**DOCUMENT 00 90 00**  
**ADDENDUM**

**ADDENDUM NO. [2]                      Date: March 21, 2018**

**RE:                      EAU CLAIRE AREA SCHOOL DISTRICT  
McKINLEY CHARTER SCHOOL  
1266 McKINLEY RD  
EAU CLAIRE, WISCONSIN 54701  
HSR PROJECT NO. 17057**

**FROM:                  HSR Associates, Inc  
100 Milwaukee Street  
La Crosse, WI 54603  
(608) 784-1830**

C100R

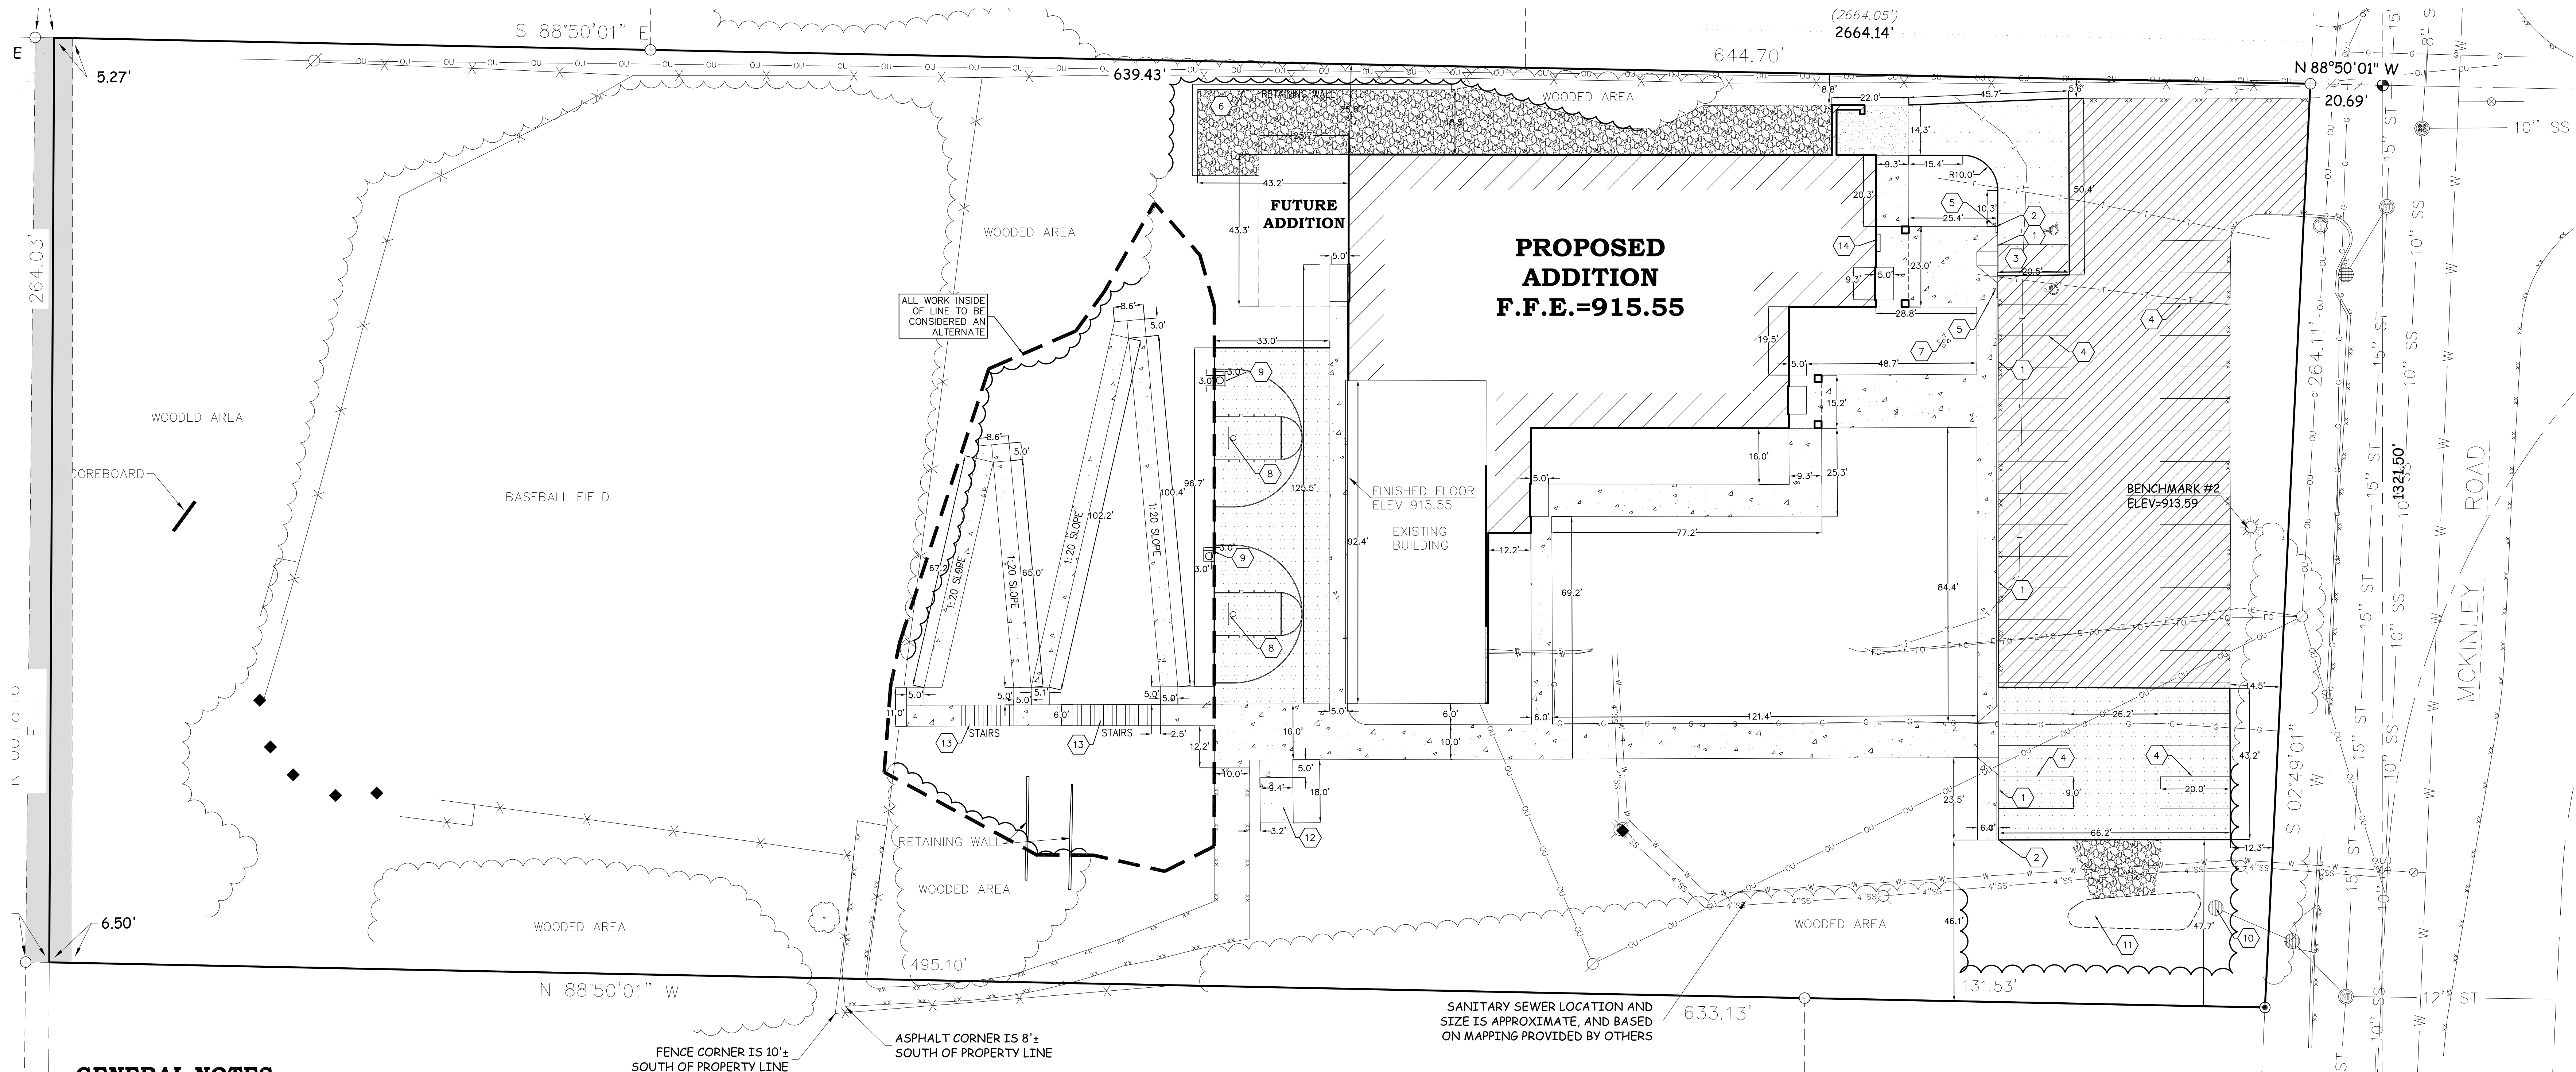
5. C100R DEMOLITION PLAN 30 x 42 attached hereto
  - a. Revisions clouded on Drawing
6. C101R LAYOUT PLAN 30 x 42 attached hereto
  - a. Revisions clouded on Drawing
7. Sheet A090 REMOVAL PLAN 30 x 42 attached hereto
  - a. Revisions clouded on Drawing.
8. Sheet A100R1 FIRST FLOOR 30 x 42 attached hereto
  - a. Revisions clouded on Drawing.

**FOUNDATION PLAN**  
1/8" = 1'-0"

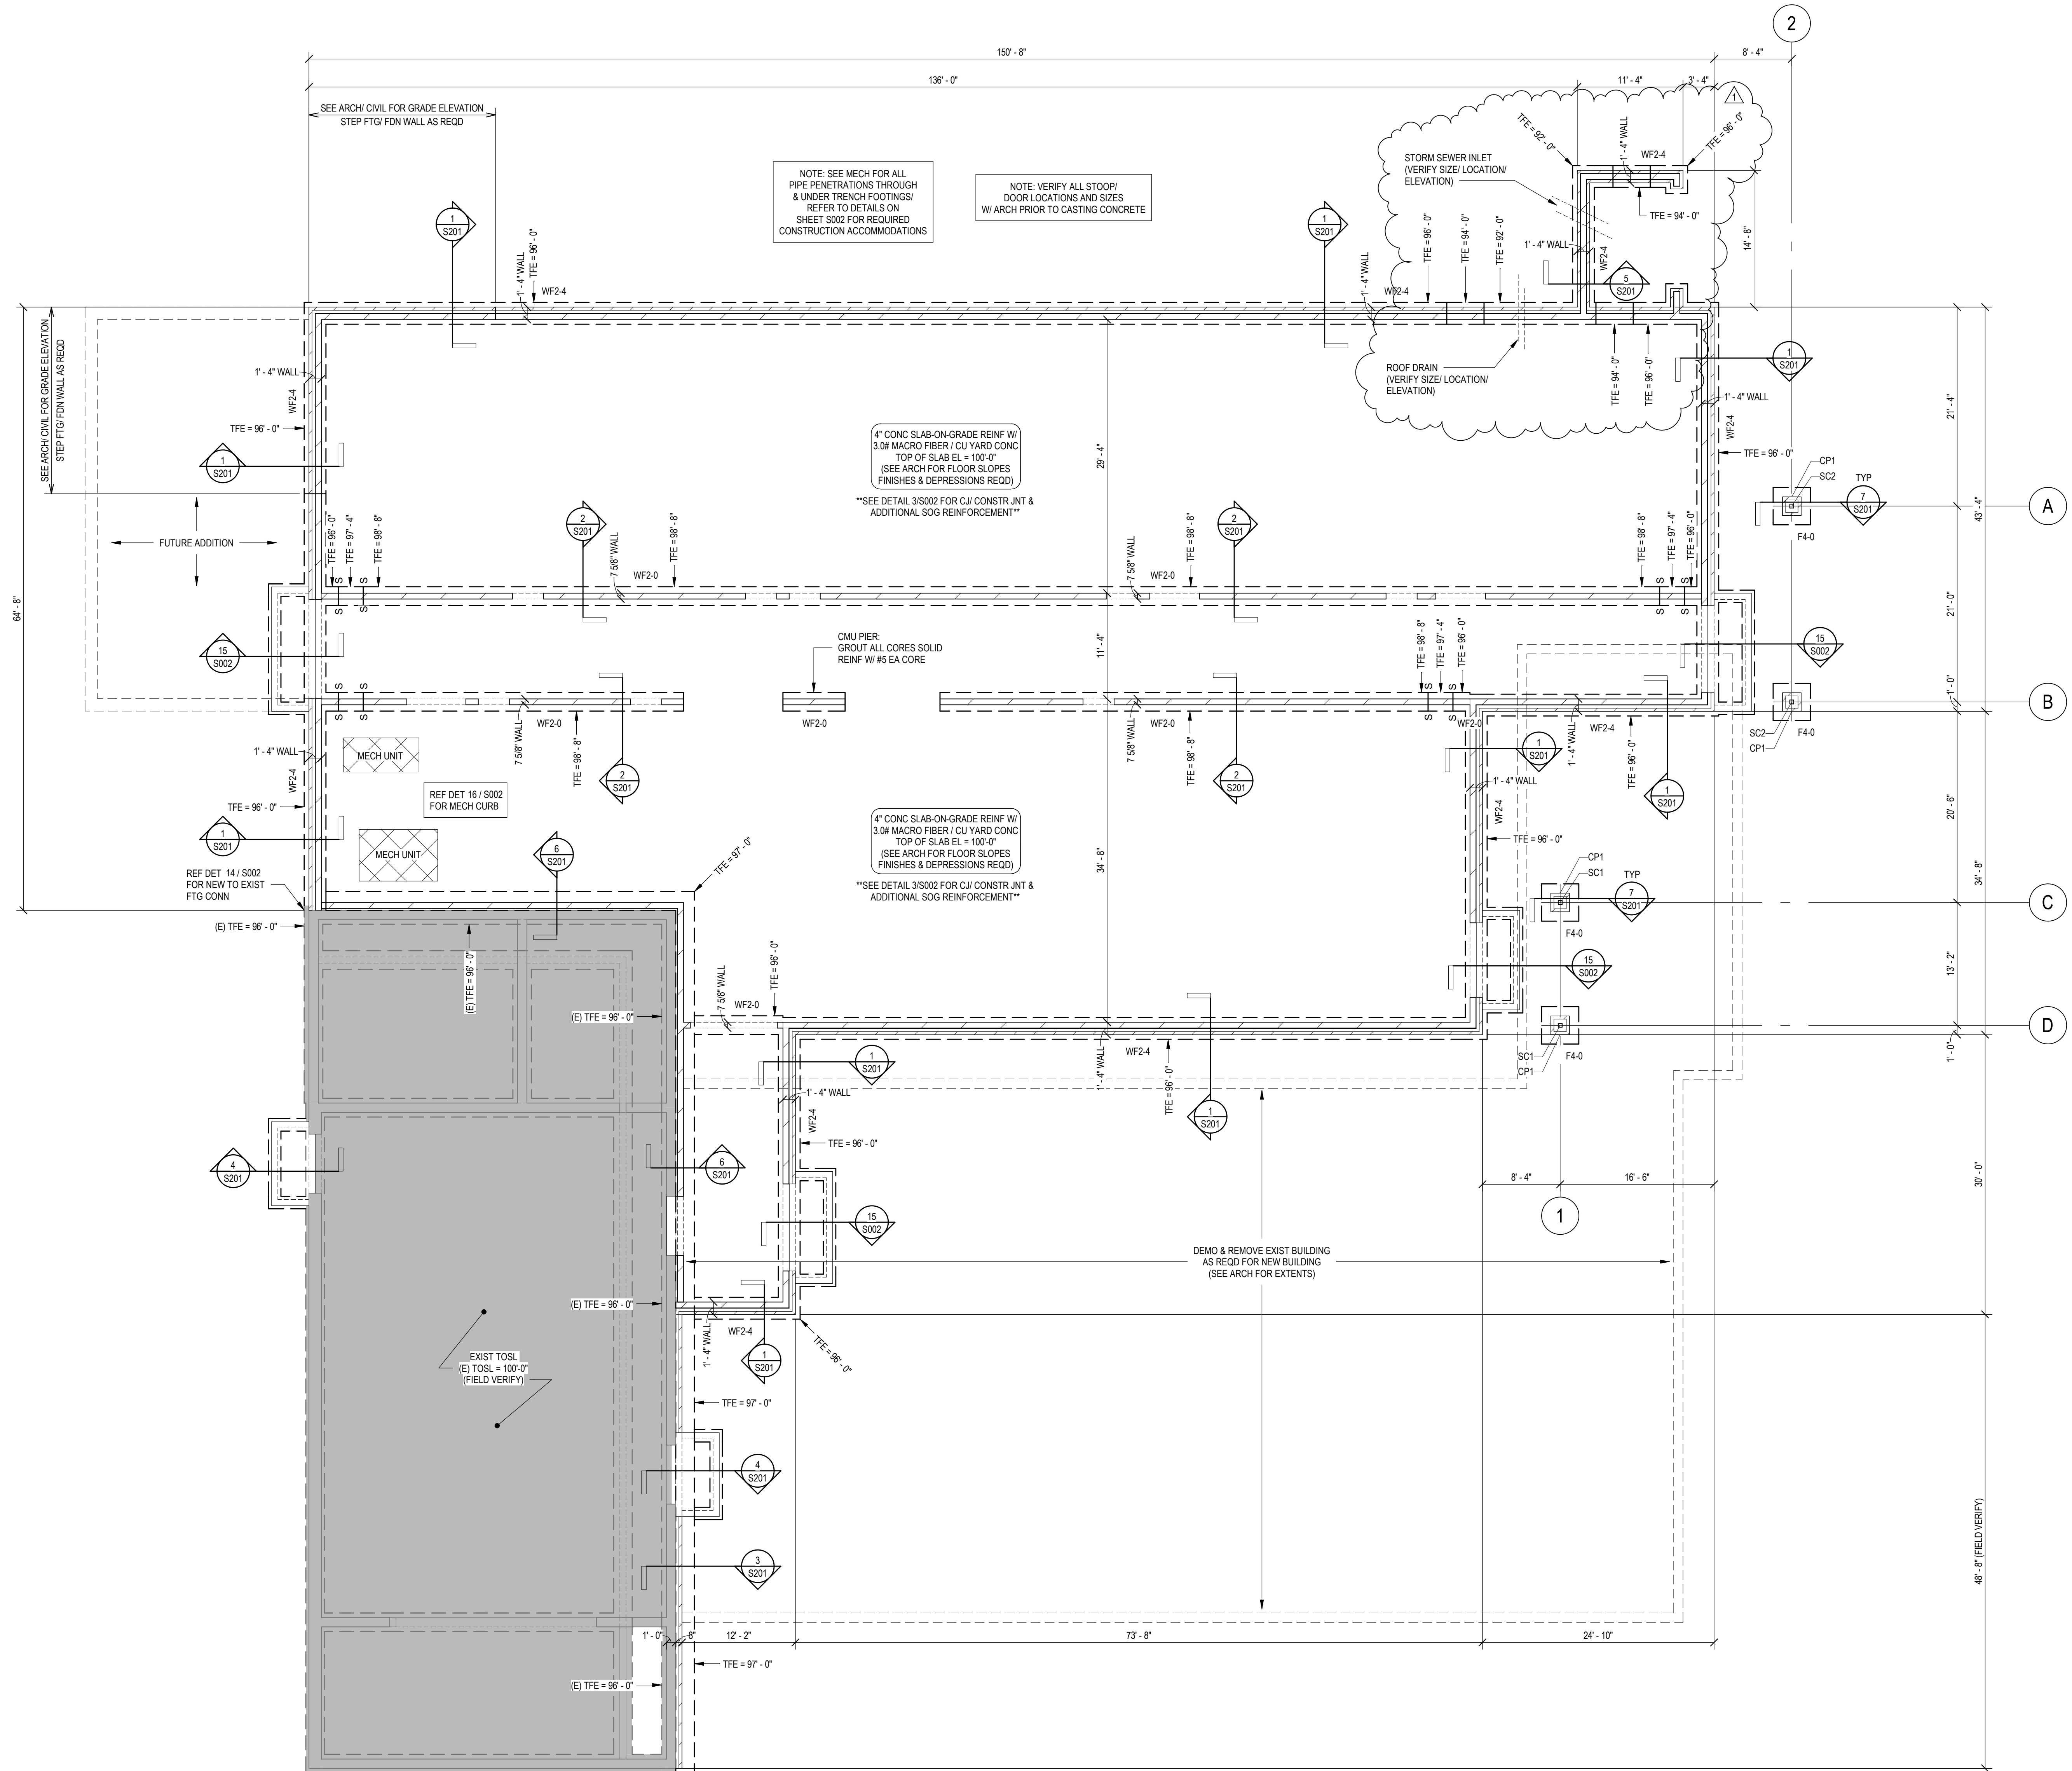
10. Sheet S110R FOUNDATION PLAN 30 x 42 attached hereto
  - a. Revisions clouded on Drawing
